UNITED STATES ENVIRONMENTAL PROTECTION AGENCY  
REGION 8

RE: East Face Design proposal 11/22/04

This is in response to your Slope Stability Analysis for the East Face of the Present Landfill sent November 22, 2004. Some discussion and update took place last week, and new models were provided to Pat Smith at our office on December 6. Technical staff met December 7 as follow-up to the modified proposal. Design Analyses were not provided for the two latest models.

OPTION B - Geosynthetic Liner Cover

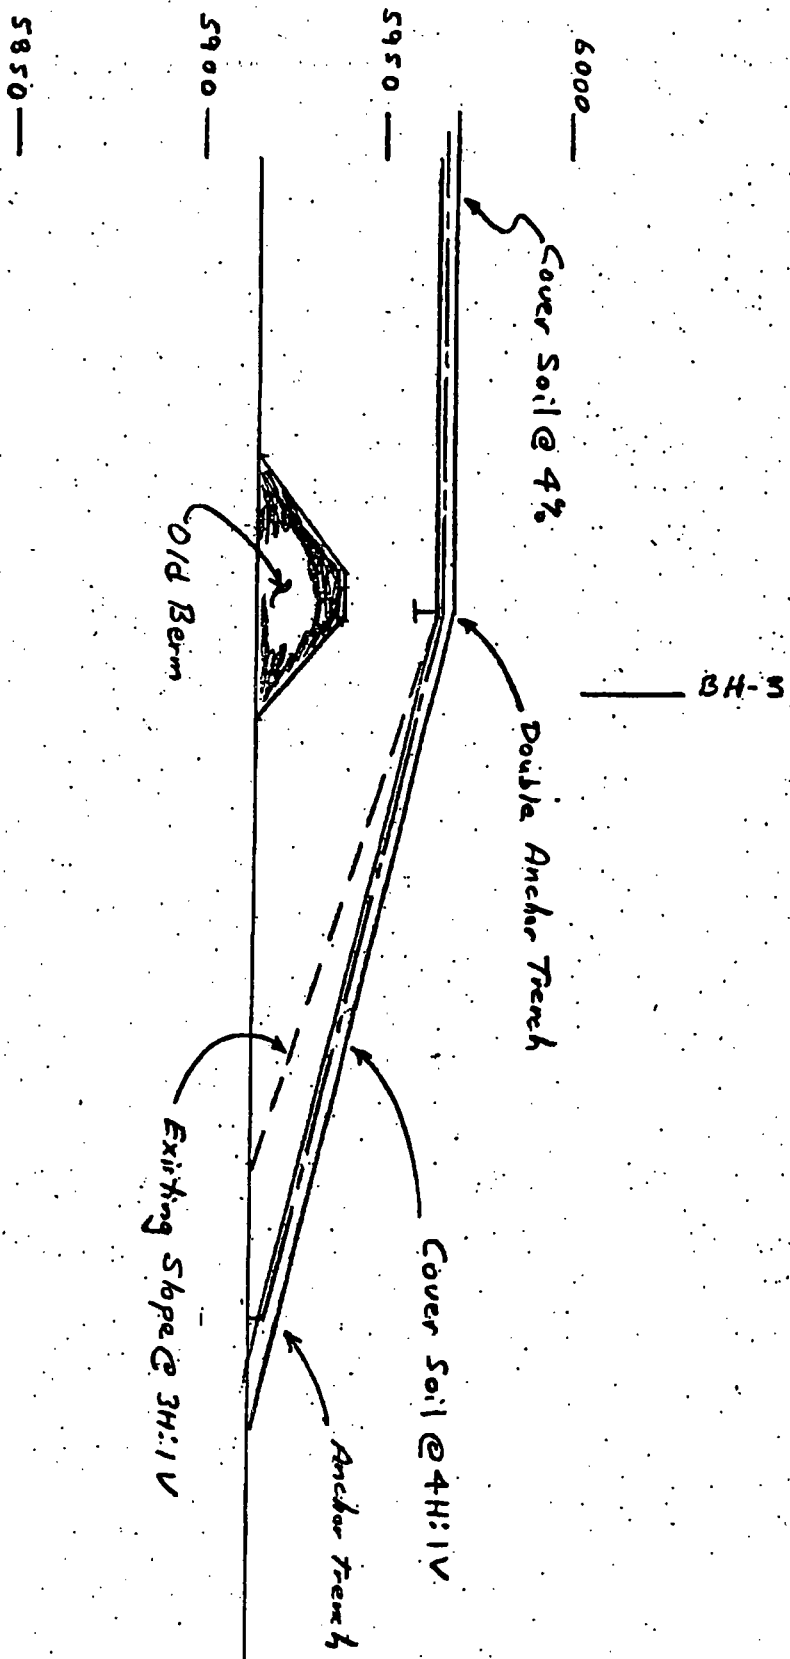
Observations made during the geotechnical field sampling event indicate 20'+ of trash in each uphill landfill borehole. This represents the presence of substantial waste east of the berm, not incidental amounts of trash. Of the three models presented, an appropriate cover for this condition is met in Option B enclosed, submitted on December 6.

We agree that time is of the essence and approve the Option B concept received this week for further design development. A complete design of the East Face and supporting calculations should provide justification for the final slope for the entire East Face of the Present Landfill. This should include details of how the East Face construction will tie into the west area construction. This comprehensive design analysis should be provided in the revised Appendix G. For further discussion on this matter, you may call me at 303-312-6251 or Pat Smith at 303-312-6504.
